COUNCIL SUBMISSION

**SSD 110354 – Wilson Park, Sydney Olympic Park
Cricket NSW Centre of Excellence**

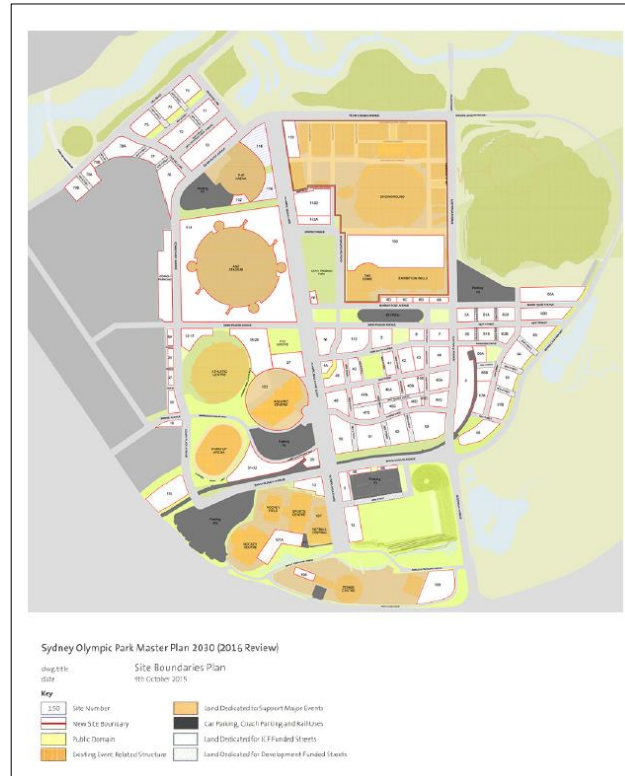
Whilst it is noted that the administration and maintenance over Wilson Park was transferred to SOPA in July 2019, the site is still subject to the current version of the Auburn Contribution Plan 2007 (Amendment No. 1) as shown in the below application maps.

In addition, from reading the latest revision of Sydney Olympic Park Local Infrastructure Contributions Framework (ICF), it is also noted that the boundary of the land applicable to the plan does not include Wilson Park, as it was last amended in October 2017.

As a result of the above findings, Council officers seek to confirm that developer contributions are to be paid to Council under the Auburn Contribution Plan 2007 (Amendment No. 1) and request details as to how the proposal will contribute towards local infrastructure improvements.
